Technical Service Bulletin: tsb100112

Released Date: 28-Jan-2002

Camshaft Gear Remover Jaw Kit

Fig.1, New Camshaft Gear Remover Jaw Kit
Part Number 3164244

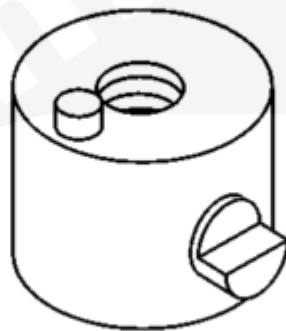
This Technical Service Bulletin introduces a new camshaft gear remover jaw kit, Part Number 3164244. The kit is used to remove L10, M11, K19, K38, and K50 camshaft gears using the mechanical camshaft gear remover kit, Part Number 3162895. The new remover kit, Part Number 3164244, obsoletes and supersedes the previous remover assembly, Part Number 3162896.

Note : The stud, Part Number 3164362, used in this kit can be slightly large for use in some existing remover plates. This can require the remover plate slots to be widened to accept the larger diameter studs.

Note : Two kits of Part Number 3164244 are required to pull the camshaft gear. Do not use in combination with the camshaft jaw remover, Part Number 3162896.

The content of camshaft gear remover kit, Part Number 3162895, has been revised to include the new remover jaws. Service Tool Instruction, Bulletin 3377781-1, has been updated to explain the procedure for using the new camshaft gear remover jaws and is included with remover jaw kit,
